## **Access Compliance Report Public Rights-of-Way** (Curb Ramps)

Intersection ID: 42759 Main Street: CHANSONETTE\_CT **Cross Street: OCONEE LN** Location: NW ADA ID: F7EB190A2560 Ramp Type: BlendTrans1 Initial Pass/Fail: Fail **Overall Compliance: No Severity Score:** 8.75

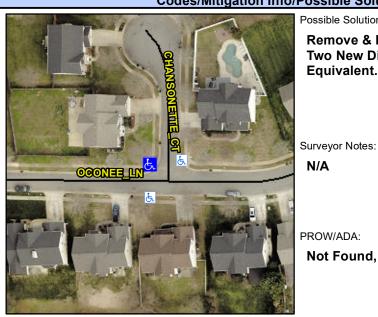
Possible Solutions: Remove & Replace Curb Ramp With **Two New Directional Ramps or** Equivalent.

Not Found, R304.5.1

Field Measurements/Component Compliance					
Compliance Description		Data	Comp	mpliance Description	
N/A	Ramp Length (in)	51.5	Yes	BlendTrans Slope (%)	3.3
No	Ramp Width (in)	42.0	Yes	BlendTrans XSlope (%)	1.2
N/A	Flare Type LT	N/A	N/A	Flare Type RT	N/A
N/A	Flare Slope LT (%)	N/A	N/A	Flare Slope RT (%)	N/A
N/A	Flare Traversable LT?	N/A	N/A	Flare Traversable RT?	N/A
N/A	Landing Length (in)	N/A	N/A	DWS Provided?	N/A
N/A	Landing Width (in)	N/A	N/A	DWS Contrast?	N/A
N/A	Landing Slope (%)	N/A	N/A	DWS Length (in)	N/A
N/A	Landing X Slope (%)	N/A	N/A	DWS Full Width?	N/A
N/A	Landing Curb? (Y/N)	N/A	N/A	DWS Offset (in)	N/A
N/A	Shared Landing?	N/A			
N/A	Gutter Ponding?	N/A	N/A	Gutter Slope (%)	N/A
N/A	Gutter Lip Ht (in)	N/A	N/A	Gutter X Slope (%)	N/A
N/A	Painted X Walk1?	No	N/A	Painted X Walk2?	No
	X Walk 1 Direction	To S		X Walk 2 Direction	To E
	X Walk 1 Width (in)	N/A		X Walk 2 Width (in)	N/A
	X Walk 1 Slope (%)	0.2		X Walk 2 Slope (%)	0.2
